**TOWN OF PLYMOUTH
PLYMOUTH MUNICIPAL AIRPORT**

**RELOCATE, RECONSTRUCT, MARK, LIGHT, AND SIGN TAXIWAY S (3,350LF X 35 FT);
RECONSTRUCT, MARK, LIGHT, AND SIGN STUB TAXIWAYS (240 LF X 35 FT EA.);**

AIP No. 3-25-0042-50

ADDENDUM No. 1

G1.3

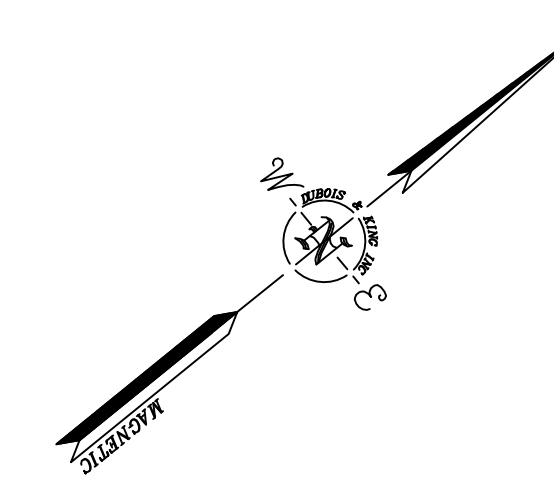
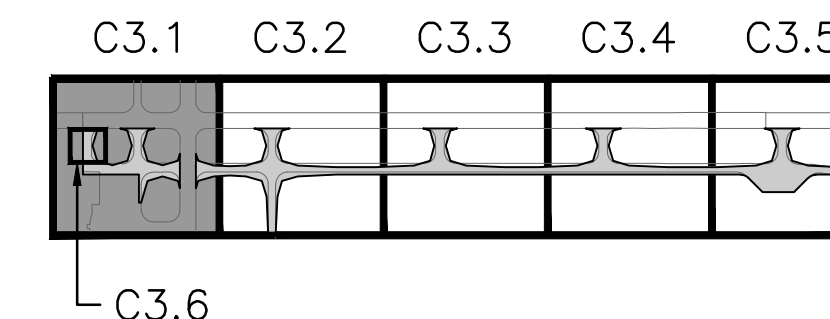
1. Drawing G1.3 Quantities sheet has been revised to reflect the new quantities for P-501-5.1 and D-701-5.2
2. Drawing No. C3.6 has been revised to clarify the limits of the proposed architectural fence vs. chain link fence.
3. Drawing No. C4.2 has been revised to clarify the sidewalk related details.

C3.6

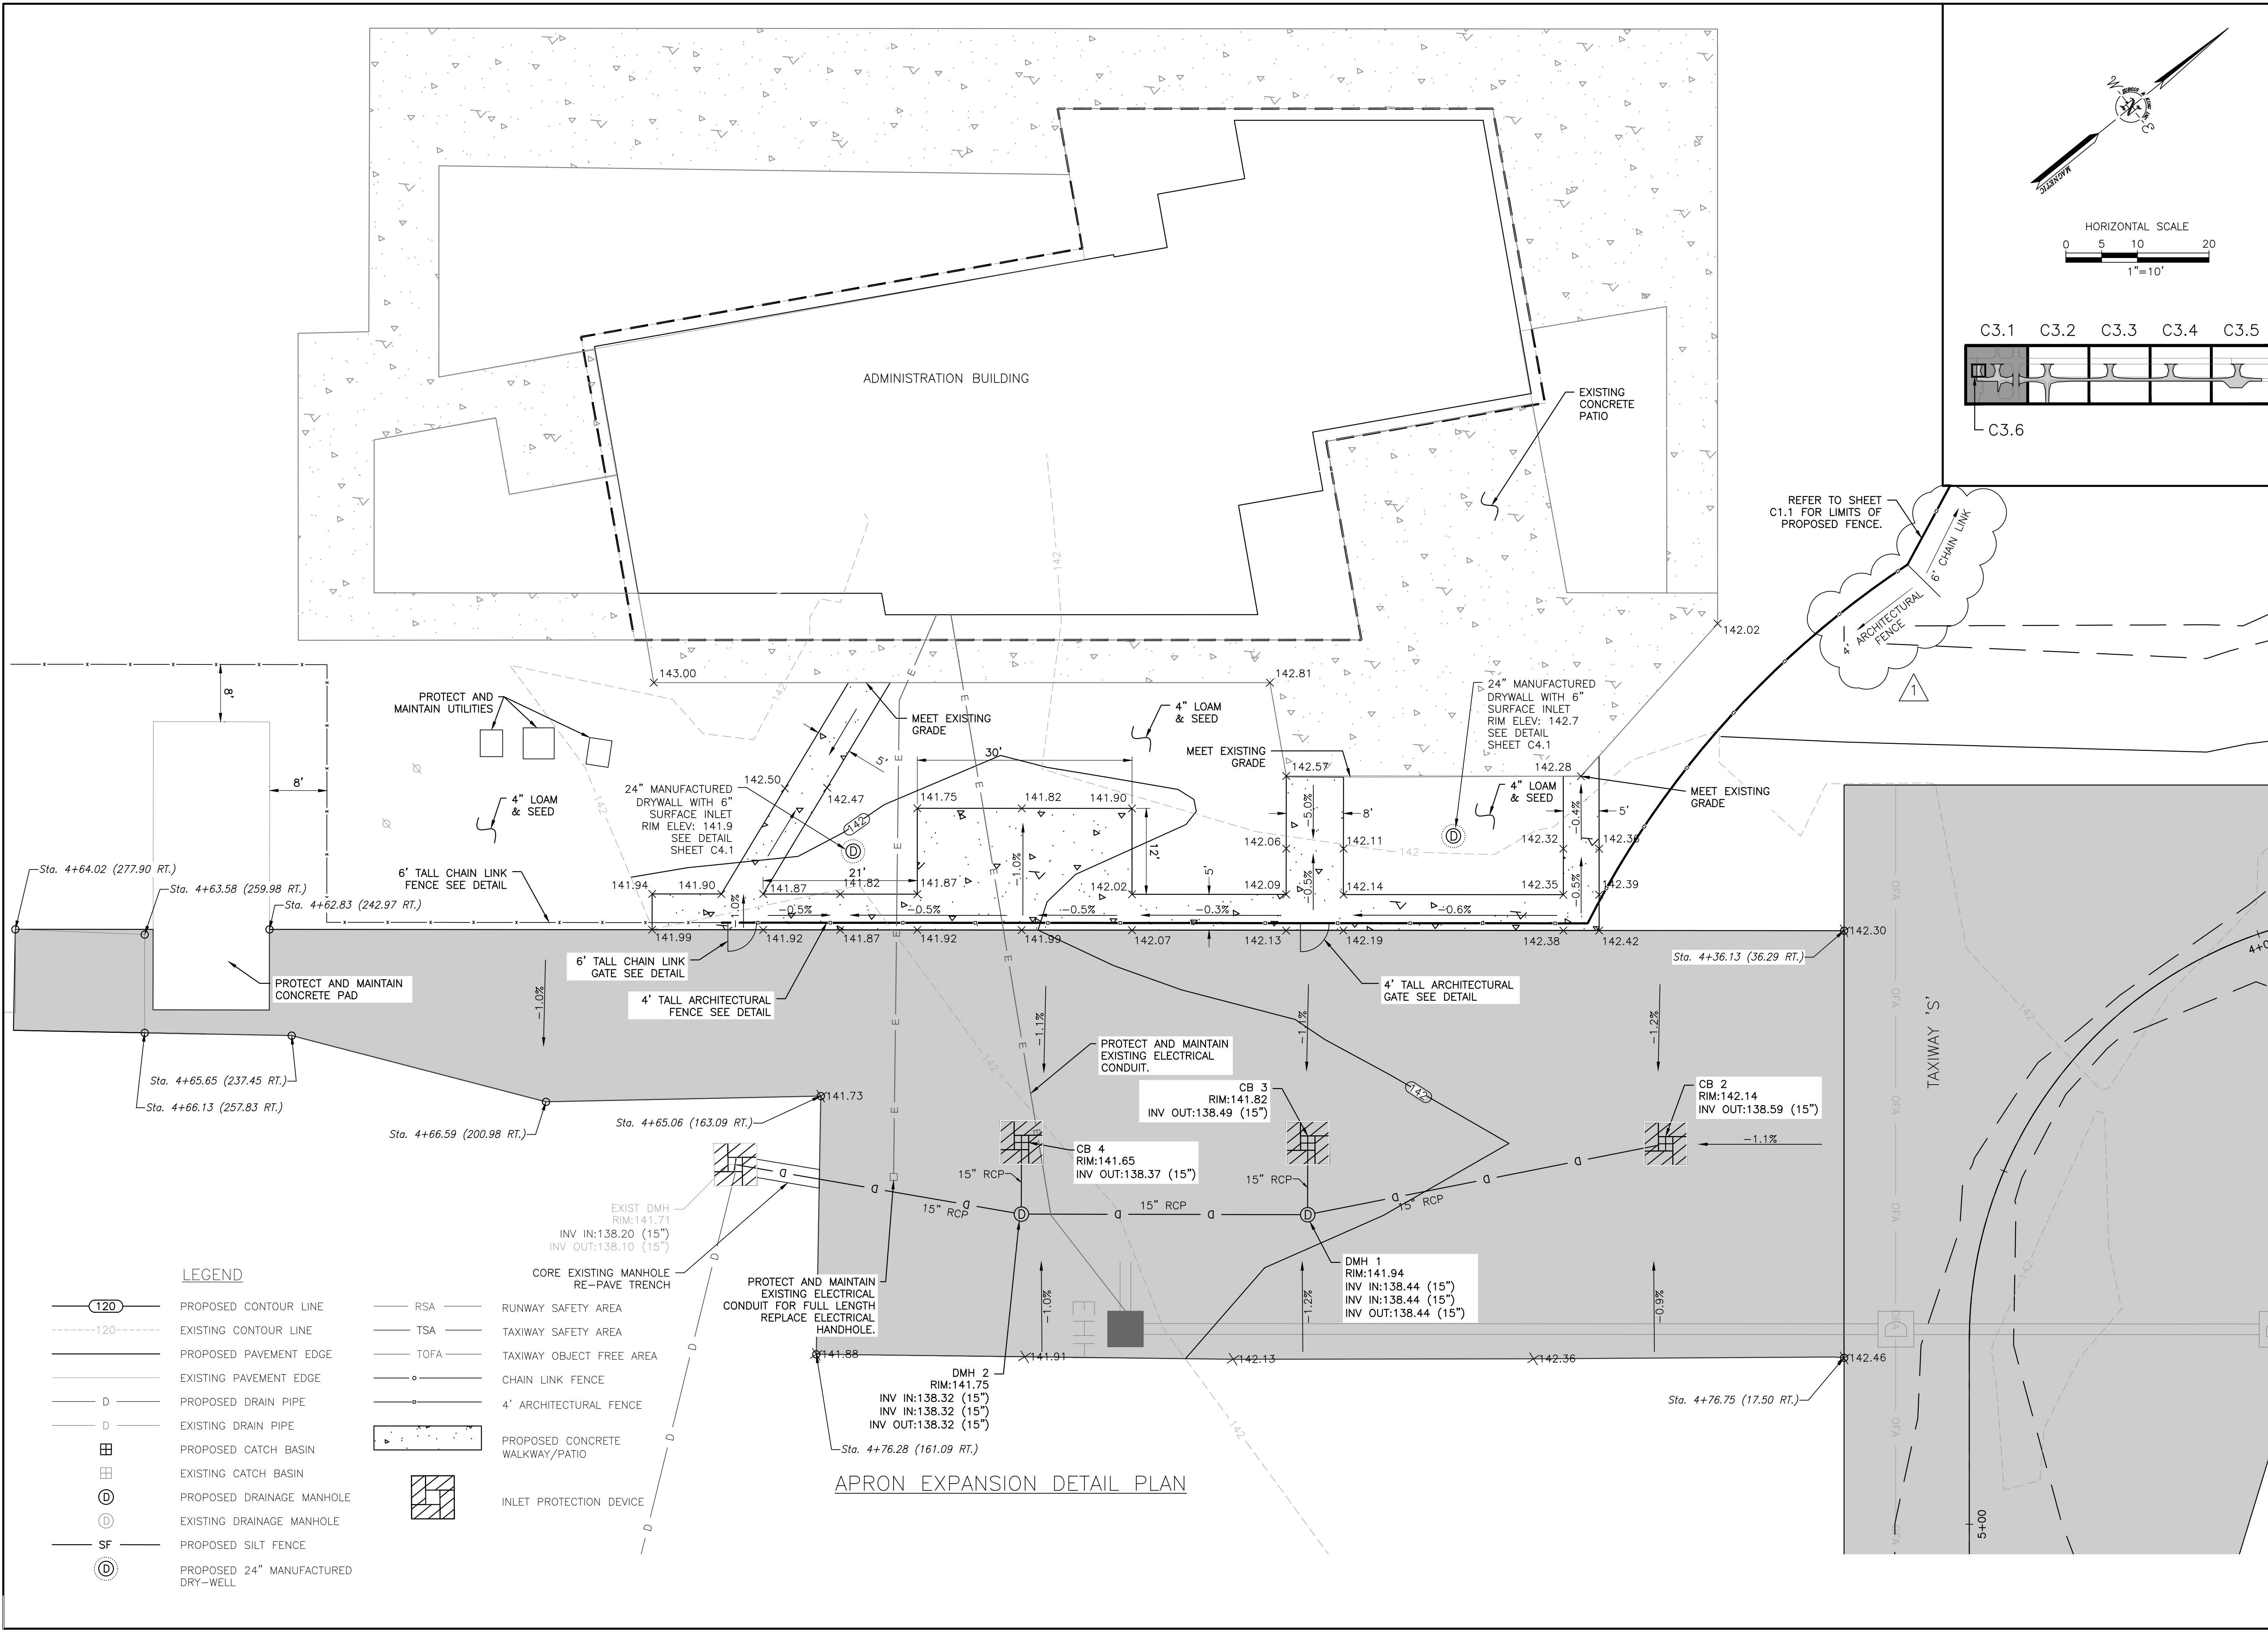
Q: What are the limits of the proposed architectural fence?

The start and stop limits have been clarified on Drawing C3.6
